PLANNING AND ZONING COMMISSION AGENDA

Regular Meeting
Wednesday, November 13, 2013
7:00 p.m.
City Hall - Council Chamber
Daniel P. Moore Community Center Complex
1900 Billy G. Webb Drive
Portland, Texas

AGENDA TITLE **SUBDIVISION FINAL PLAT**
 The Planning and Zoning Commission will consider the final plat of Northshore Unit 3, Block 14, Lots 11R, 12R, and 13R

AGENDA TITLE **SUBDIVISION PRELIMINARY PLAT**
 The Planning and Zoning Commission will consider the preliminary plat of Northshore Unit 5B

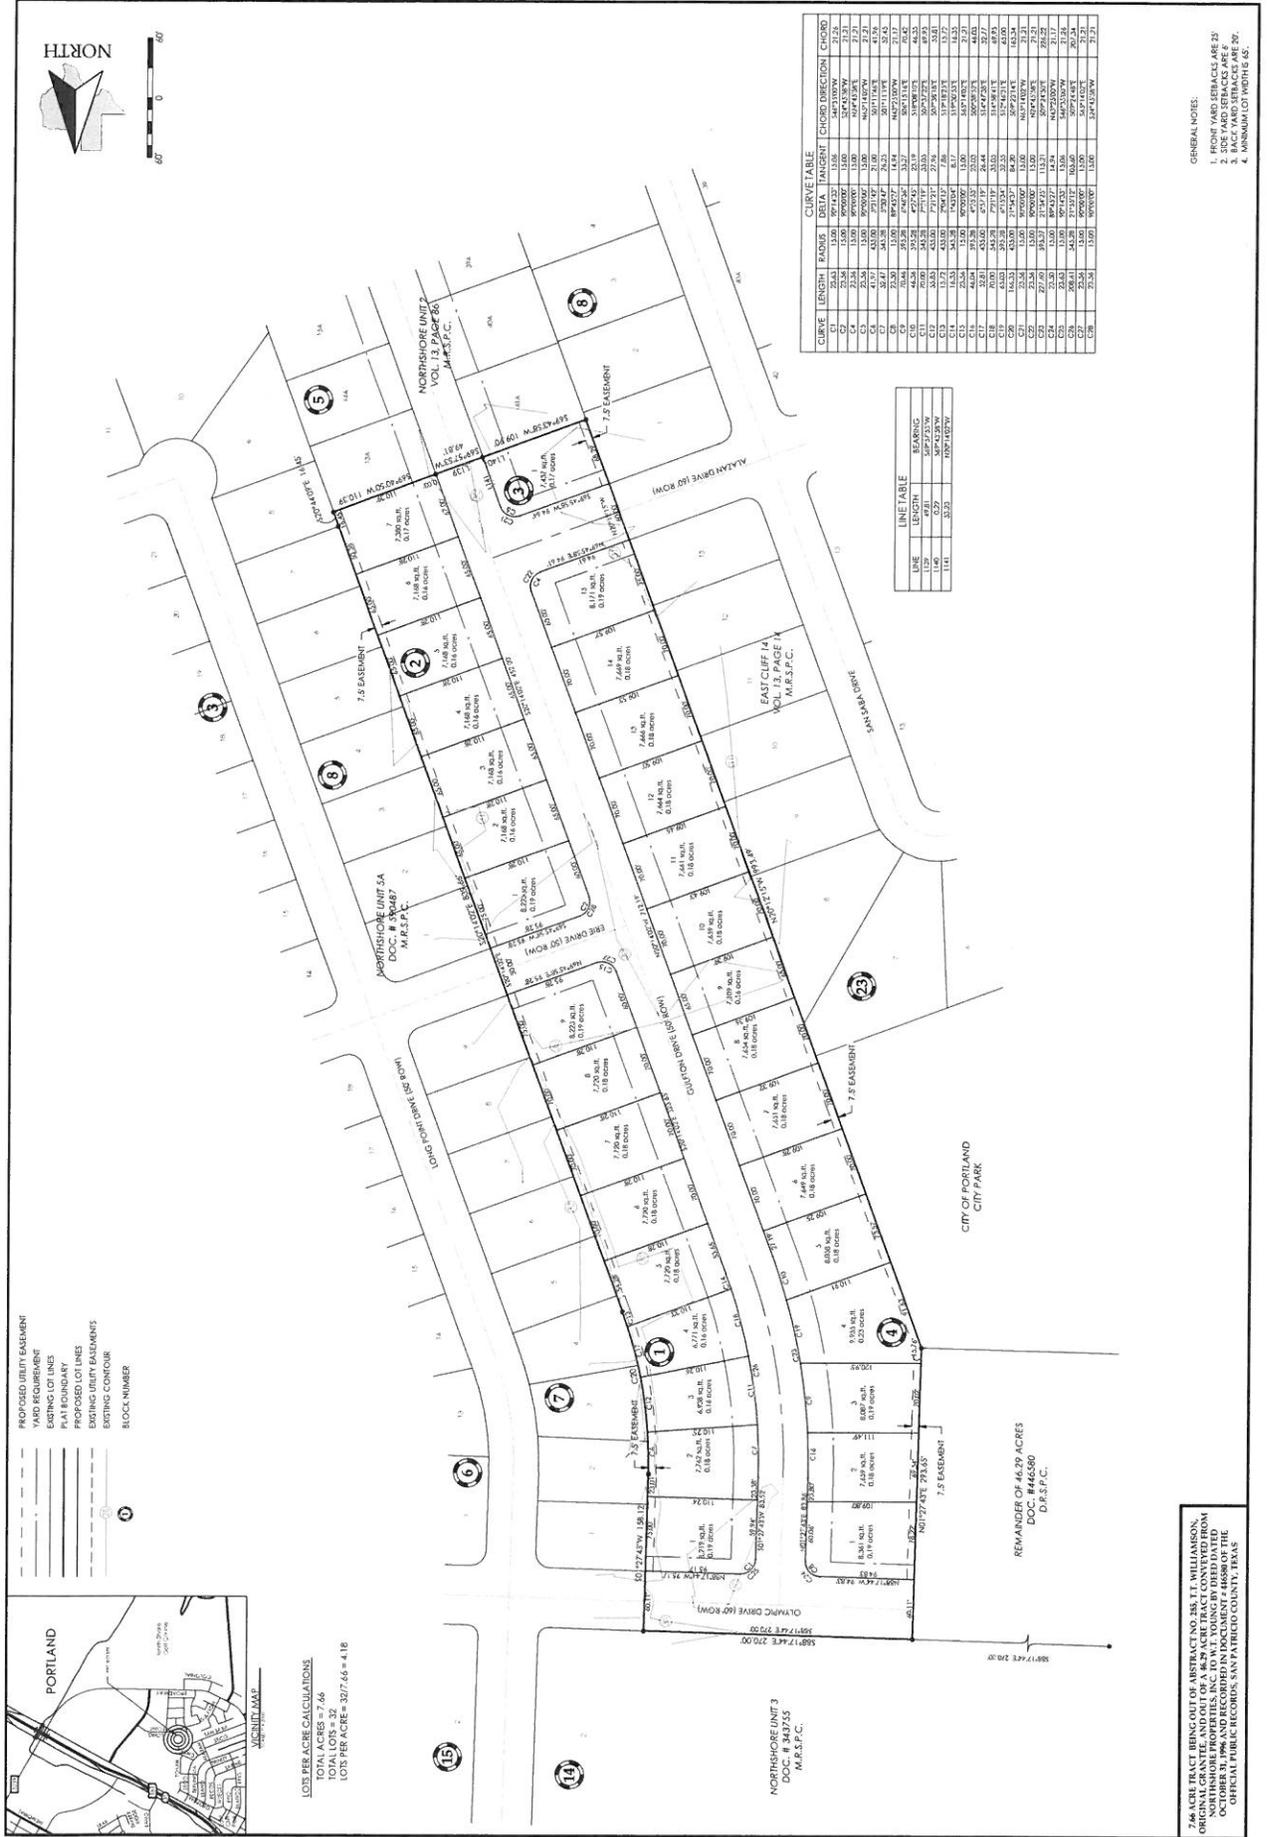
Staff review of the final plat shows that the dimensions proposed meet the district’s requirements.

Access: Access is provided onto Gulfton Drive, Erie Drive, and Olympic Drive in compliance with the City’s Thoroughfare Plan. Driveway access to Block 1 Lot 1, and Block 4 Lot 1 is recommended to be restricted to Gulfton Drive.

Utilities: 8-inch water lines and 10-inch wastewater lines are proposed to run between the curb and sidewalks. The lines are sized appropriately for current and future demands.

Drainage: The applicant has noted that the property lies within FEMA FIRM Zone "C". Finished floor elevations will be based on adjacent curb elevations in conformance with City codes. Curb inlet spacing is shown appropriately to connect into the existing drainage systems.

Adopt a motion that approves the preliminary plat of Northshore Unit 5B, subject to the following conditions:

- (1) Compliance with all City of Portland ordinances, rules, and regulations
- (2) Payment of all platting fees and review fees
- (3) Driveway access to Block 1 Lot 1, and Block 4 Lot 1 is restricted to Gulfton Drive
